ADDENDUM NO. 3

Project: **CONTRACT NO. 18-1
MINERSVILLE AREA SCHOOL DISTRICT
NEW SOFTBALL / TRACK RESTROOMS**

END OF ADDENDUM
LA Project No. 12-026

TYPE 2-S GUIDE RAIL DETAIL
N.T.S.

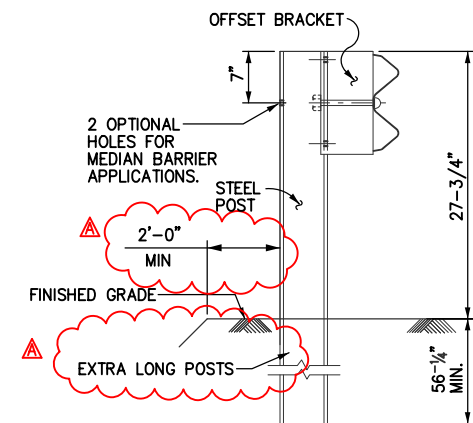
- F. Refer to attached Guiderail Detail. Guiderail updated to show extra-long posts and 2'-0" Min level area behind guiderail on accordance with PADOT RC-51M. (1 page)

Rev	Date	By	Chk'd	Description
A	03/26/2018	SJR	CGB	GUIDE RAIL DETAIL UPDATE, EXTRA LONG POST, 2'-0" MIN
